CROW BUTTE URANIUM PROJECT

**Application and Supporting Environmental
Report for State of Nebraska
Underground Injection Control Program
Commercial Permit**

ERRATA SHEET

ERRATA SHEET DEC Completeness Review

REV.	FERRET OF NEBRASKA, INC.		
DATE			
	CROW BUTTE PROJECT		
	Dawes County, Nebraska		
	ENGLISH CREEK AND		
	SQUAW CREEK WATERCOURSES		
	PREPARED BY: F.E.N.		
	DWN. BY: JC	DATE: 8/87	FIGURE: 4.4-1

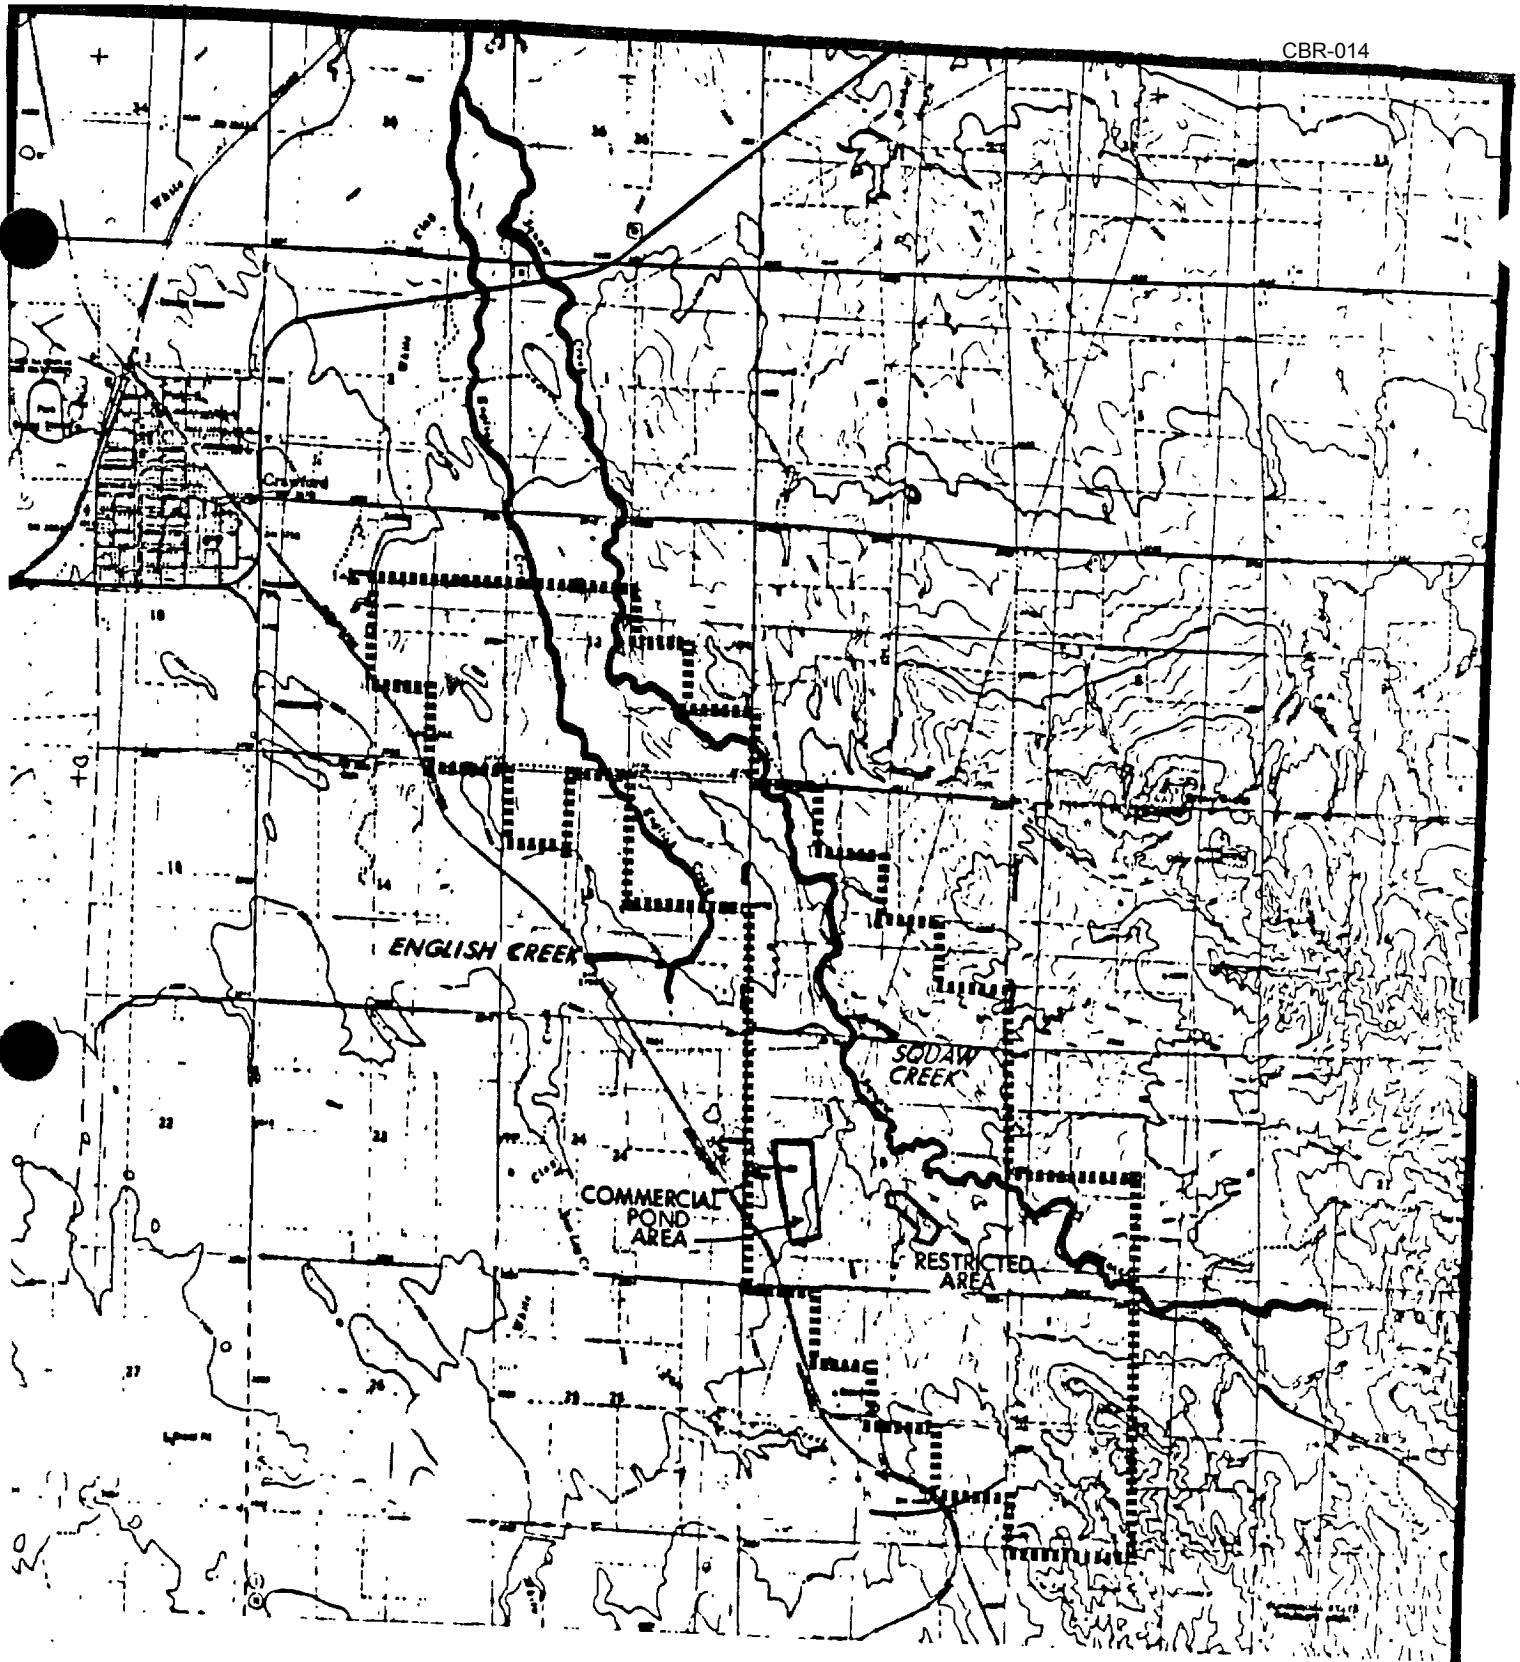
1. The following permits or construction letters must be added on Page 1 of the introduction:
Class V 5W-11
Septic Tank
Pond Permit
Water Resources Permit
2. Page 4.4(3); Figure 4.4-1, no scale.
3. Page 4.4(14); toward is misspelled.
4. Page 4.4(16); Figure 4.4-7, no scale.
5. Page 4.5(22); typing error; should read "the".
6. Page 4.5(25); P. 3 L4-5, are there some words missing?
7. Page 4.7(15); local economy has misplaced comma.
8. Page 4.8(3); L2-3 should read "published" instead of "publisted?"
9. Page 4.8(53); P.2 L1 featire number is missing.

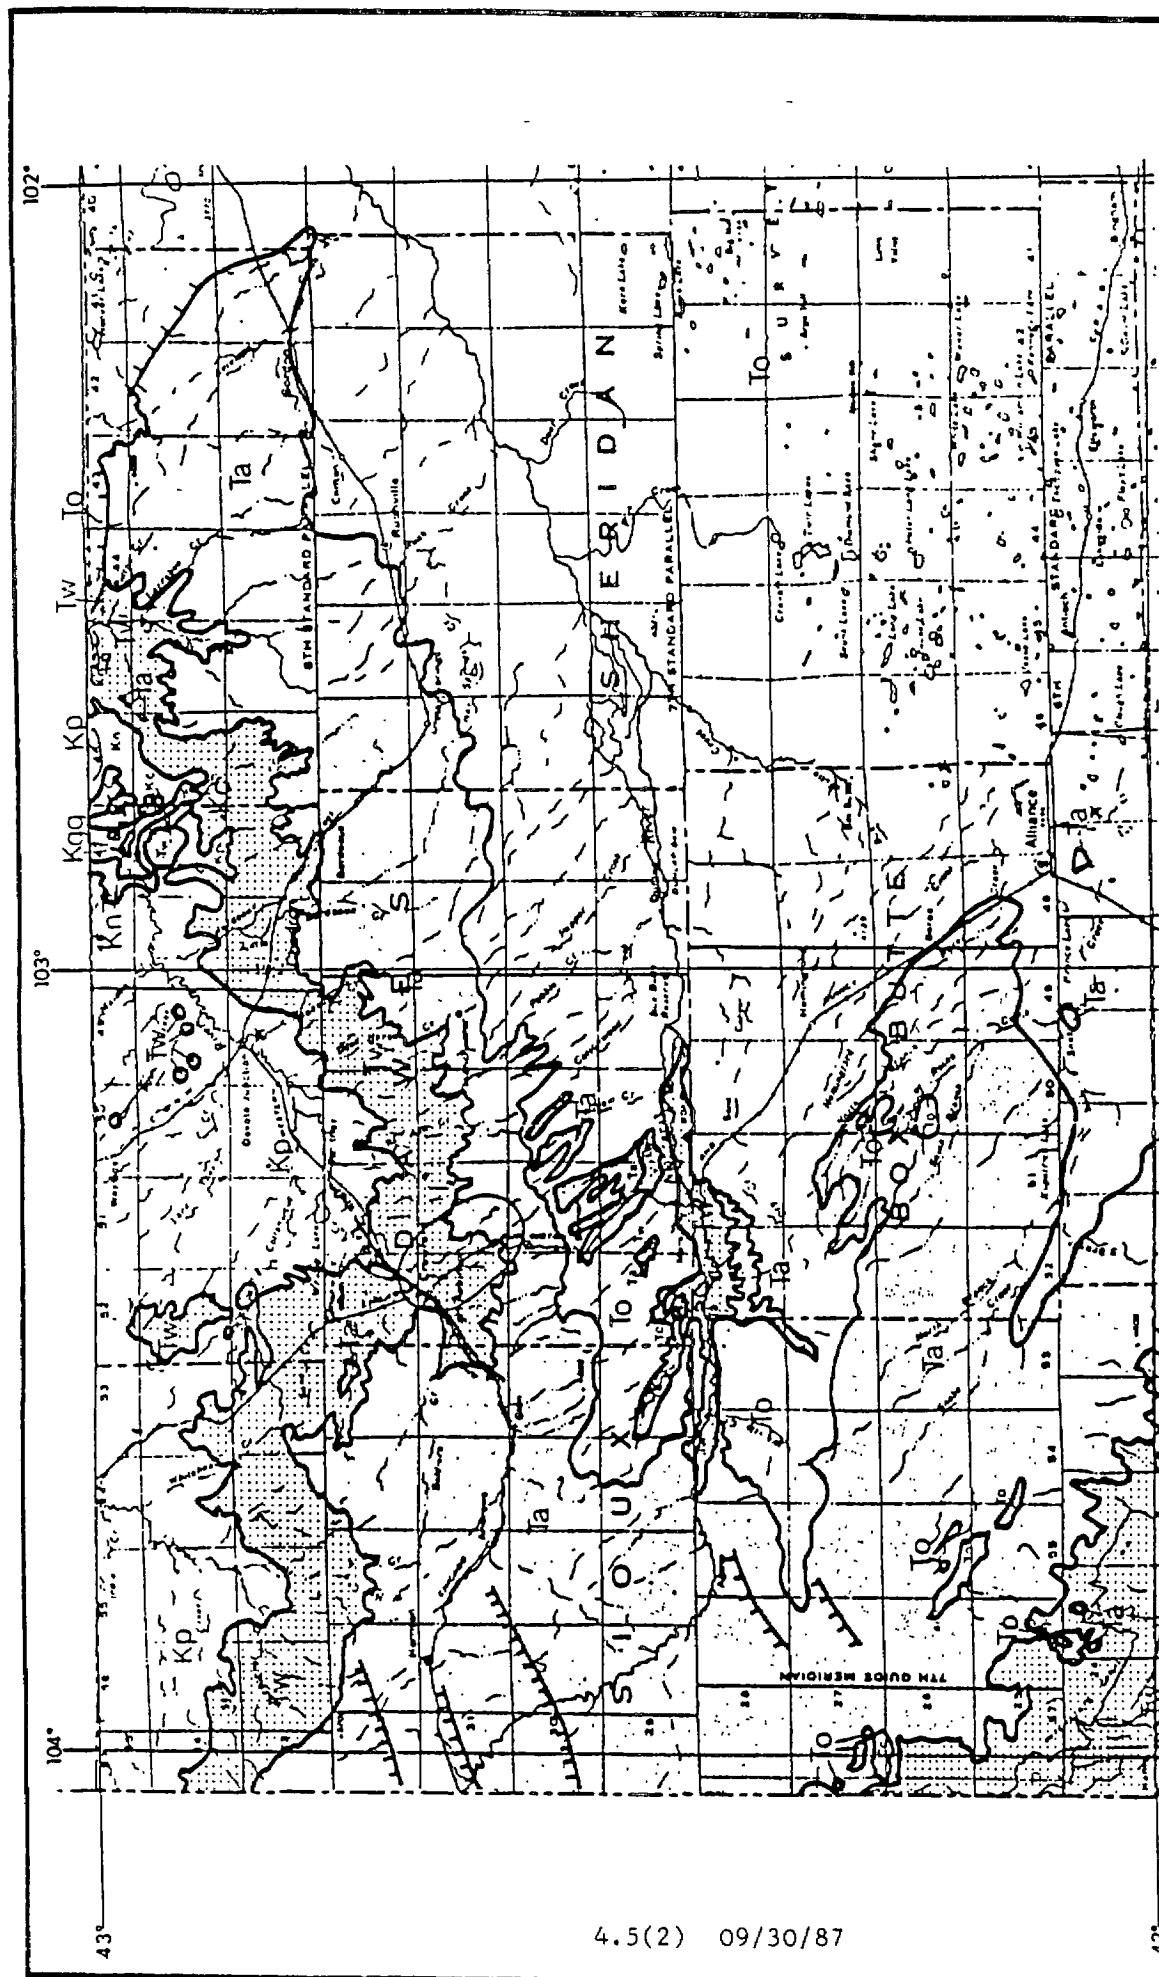
2. Subsection 4.5, Geology
p.4.5(2), Figure 4.5-1. Figure has been reduced to a point where it is unreadable. Needs to be redone.

p.4.5(8) to 4.5(10) Regional Structure. FEN's interpretation of the regional structure needs to be shown on a map. Figure 4.5-1 is inadequate. The map should include features such as (1) Crawford Basin, (2) Inner Crawford Basin, (3) White River Fault, (4) Cochran Arch, (5) Toadstool Park Fault, (6) Bordeaux Fault, (7) Pine Ridge Fault, (8) Chadron Arch, etc.

FEN has included the State Geologic Map of Nebraska as Figure 4.5-1 as the accepted regional structure.
